HISTORIC AND DESIGN REVIEW COMMISSION

July 19, 2023

HDRC CASE NO: 2023-248
ADDRESS: 211 LOSOYA ST
LEGAL DESCRIPTION: NCB 914 BLK LOT W IRR 116.2 FT OF A2 -C
ZONING: D, H, HL, RIO-3
CITY COUNCIL DIST.: 1
DISTRICT: Alamo Plaza Historic District
APPLICANT: Joseph Marroquin Sr/Colt Professional Facility Repair
OWNER: ASHITA INVESTMENTS LLC
TYPE OF WORK: Fencing
APPLICATION RECEIVED: June 14, 2023
60-DAY REVIEW: August 13, 2023
CASE MANAGER: Jessica Anderson

ARCHWAY GATES 1 SET

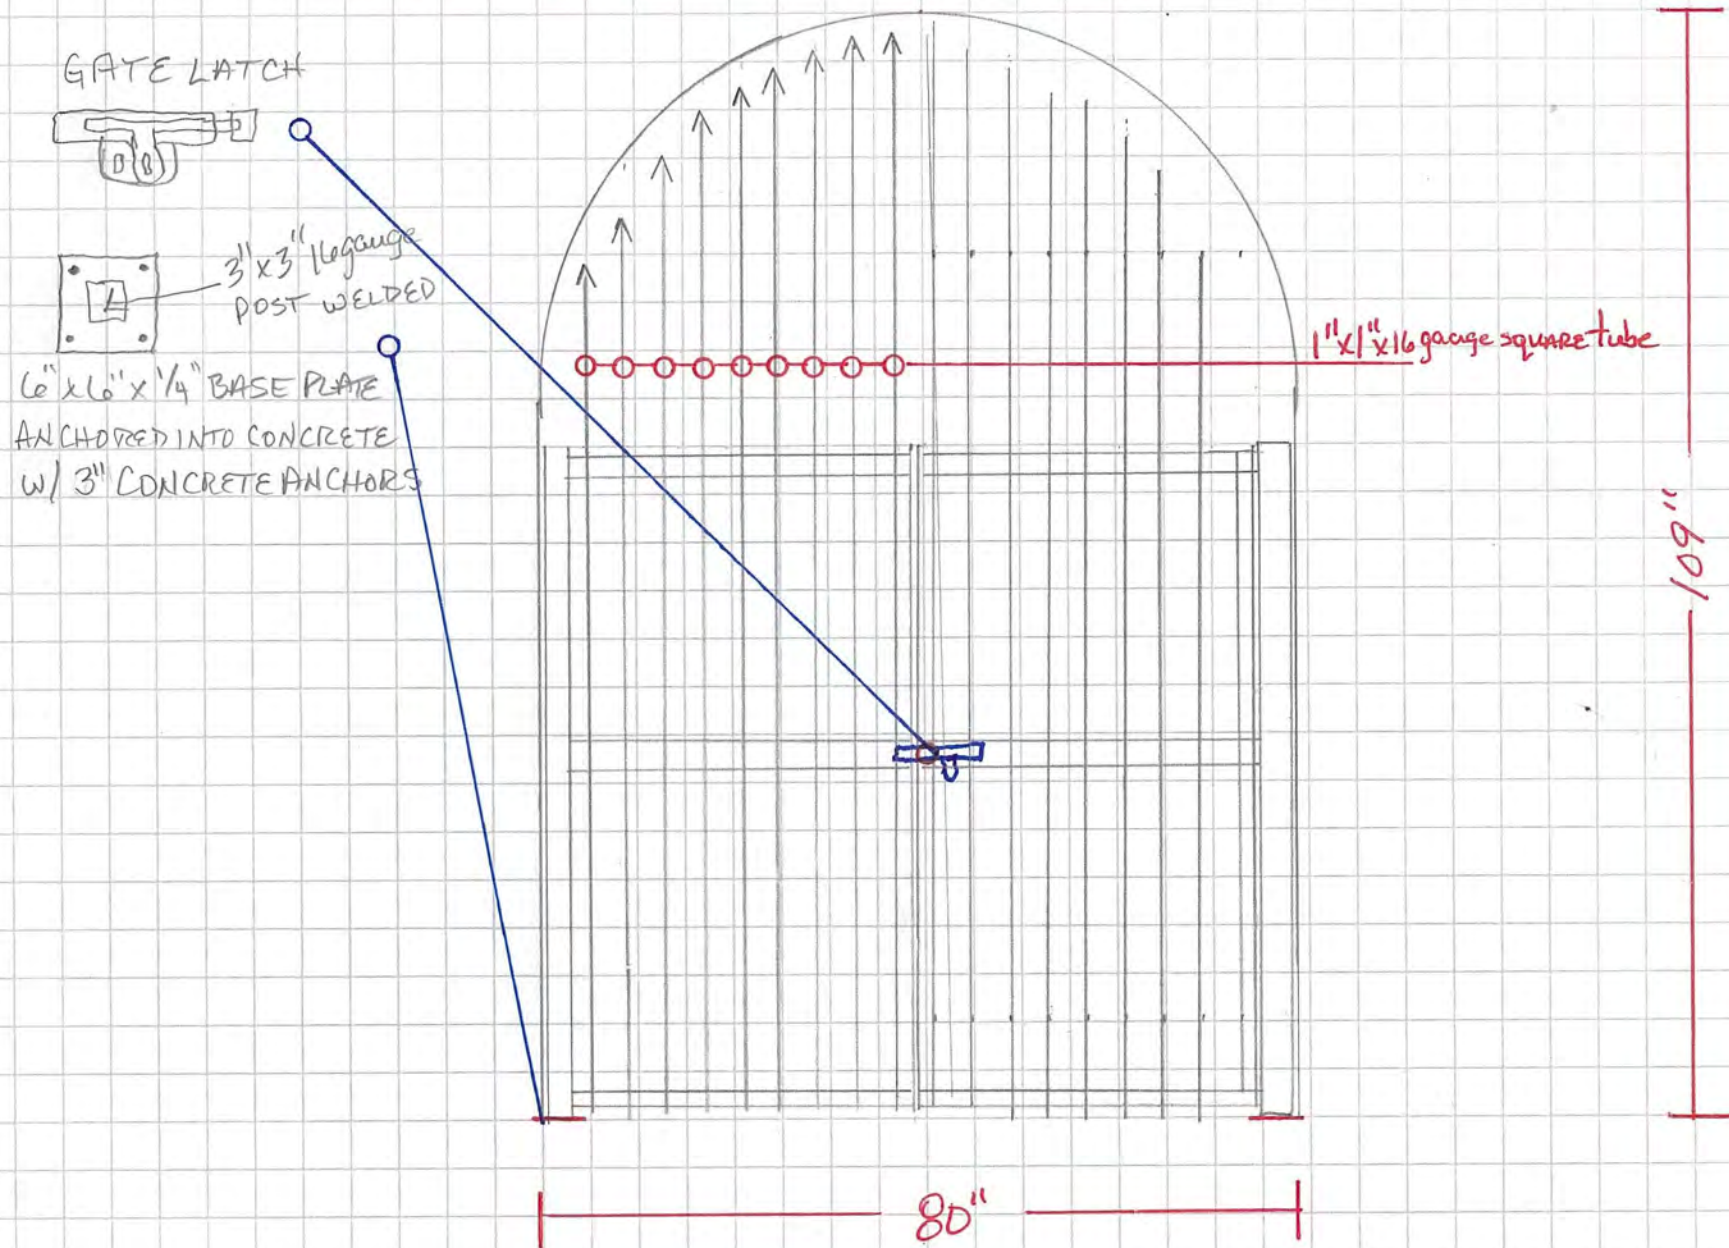
- b. The applicant requests to install three metal fence panels and one metal gate inside the existing brick arches. The applicant indicates the fences and gate will be attached at the base and not in the brick. Historic Design Guidelines for Exterior Maintenance and Alterations 2.B.i says do not introduce new facade elements that alter or destroy the historic building character, such as adding inappropriate materials; altering the size or shape of windows, doors, bulkheads, and transom openings; or altering the façade from commercial to residential. Alterations should not disrupt the rhythm of the commercial block. The proposed fence panels and gate are made of an appropriate material, will be attached at the base and not into the masonry so as not to destroy historic fabric, and they do not alter the size or shape of the existing archways. Staff finds the request conforms to guidelines.

Staff recommends approval of the request to install three metal fence panels and one metal gate inside the existing brick arches, based on findings a and b.
